Combined License Application Review Vogtle Units 3 and 4

SER Panel 1

September 27 – 28, 2011

AP1000 Shield Building Design

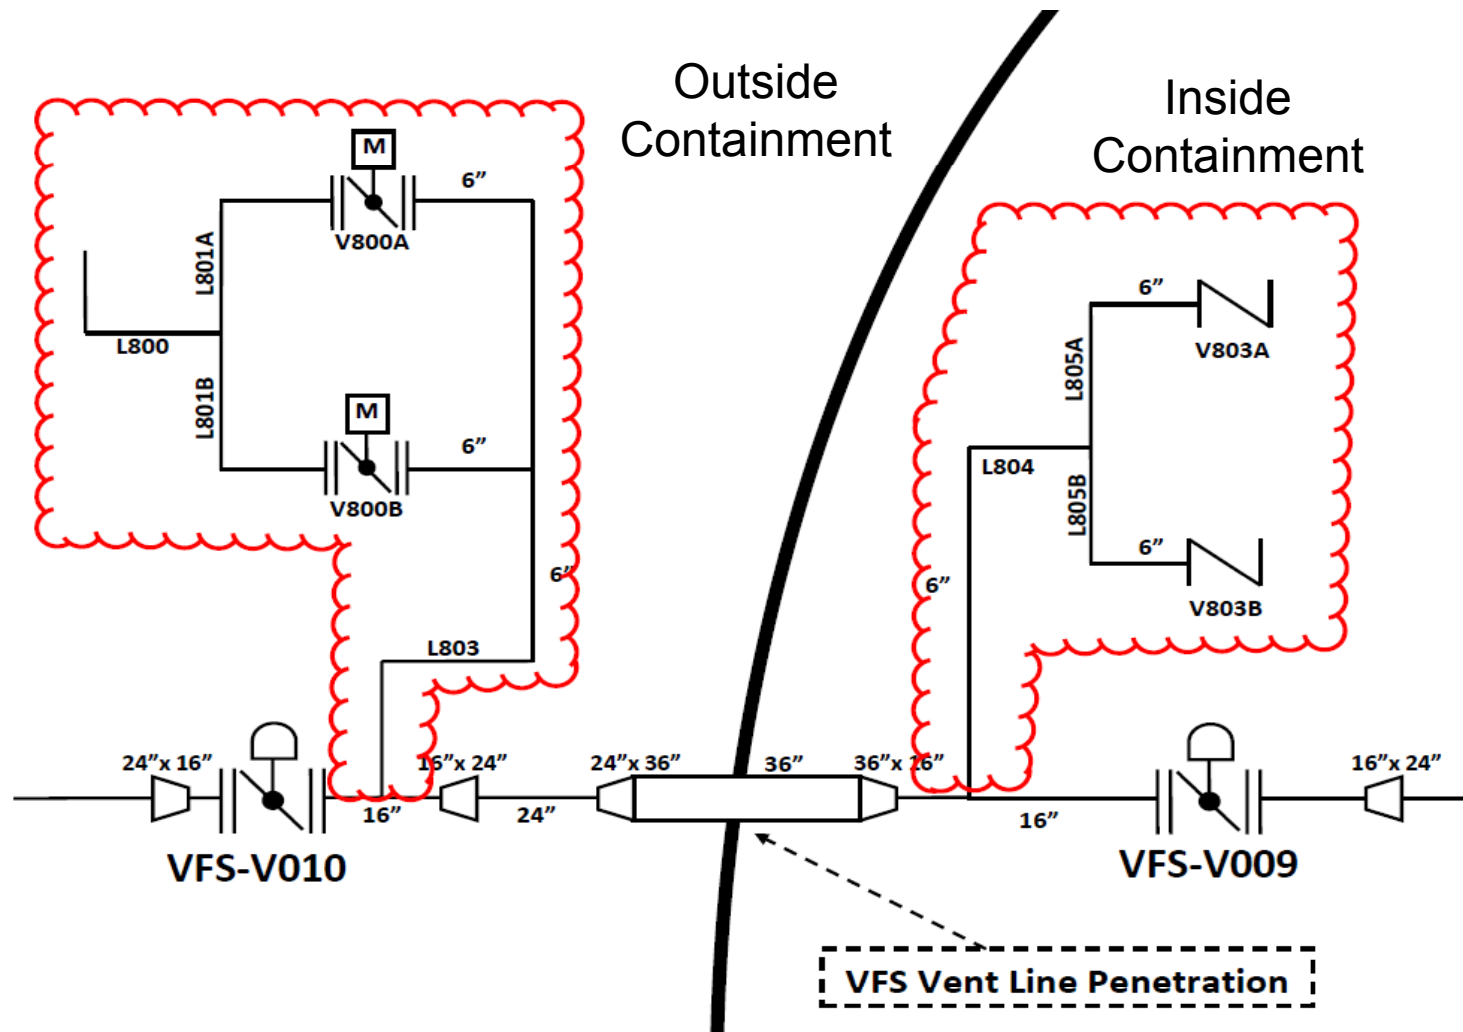
- Revised design for improved aircraft impact resistance
- First of a kind use of modular construction
- Review for external events (e.g., seismic)
- Inspection of supporting information on aircraft impact performance
- Revision 19 additional topics
